Request For Information - 037

The Cora Apartments (19 W Harrison)

Subject:	**Tub & Shower Installation Details Clarification**	**Status:**	**Open**

3 TYPICAL TYPE "A" BATHROOM FIXTURE LOCATIONS

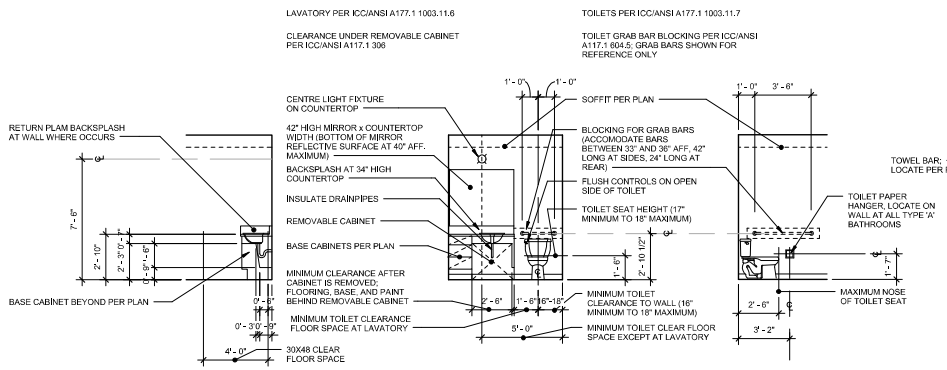
1. Drawing 3/A0901 & 4/A0901 (type A & B bathrooms) shows the tub controls at 2'-0" AFF. The top of the tub (at the tub surround) is at 17". The tub control faceplate is 7" dia., which leaves only 3 ½" for the tub spout. The installer suggests moving the controls from 2'-0" to 2'-9". Please confirm this is acceptable.

Item #1:
Mount the Controls at 2'-4" height AFF.

4 TYPICAL TYPE "B" (OPTION A&B) BATHROOM FIXTURE LOCATIONS

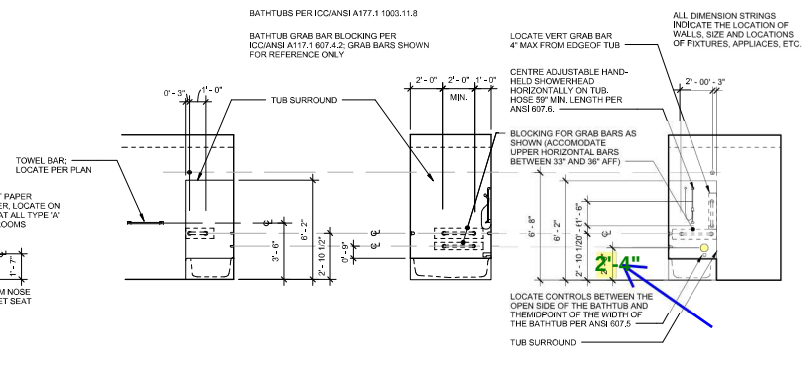
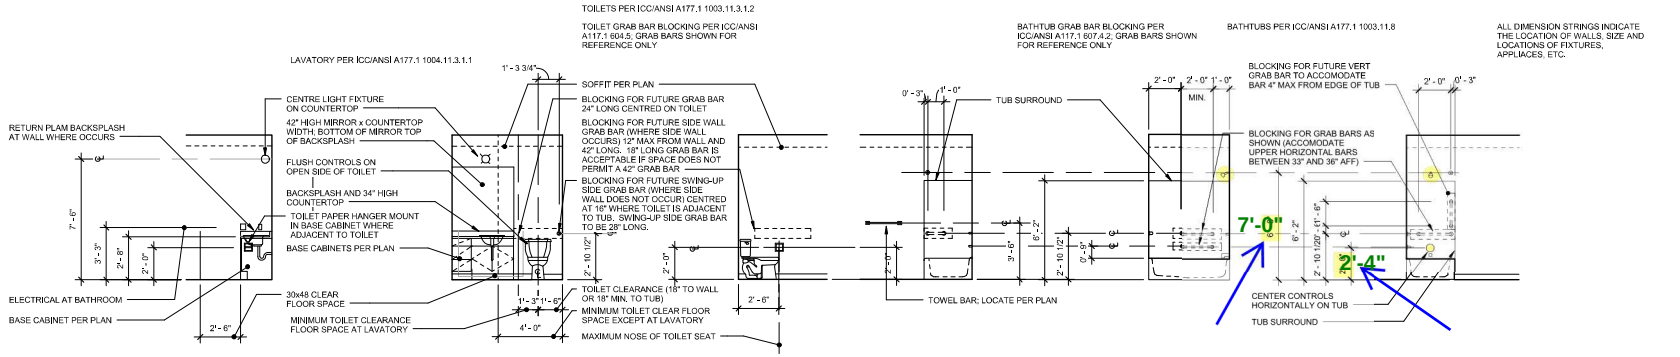
3. Drawing 4/A0901 shows the shower heads located at 80" AFF. The top of the tub enclosure is at 79 ¼" AFF. The top of the shower stall enclosure is at 77 ¾". Since it's so close, could the shower head be moved up to 84" AFF? Please confirm that's acceptable. (type A bathrooms will have hand shower with hose).

Item #3:
Yes, it is acceptable to move shower heads up to 84" AFF.
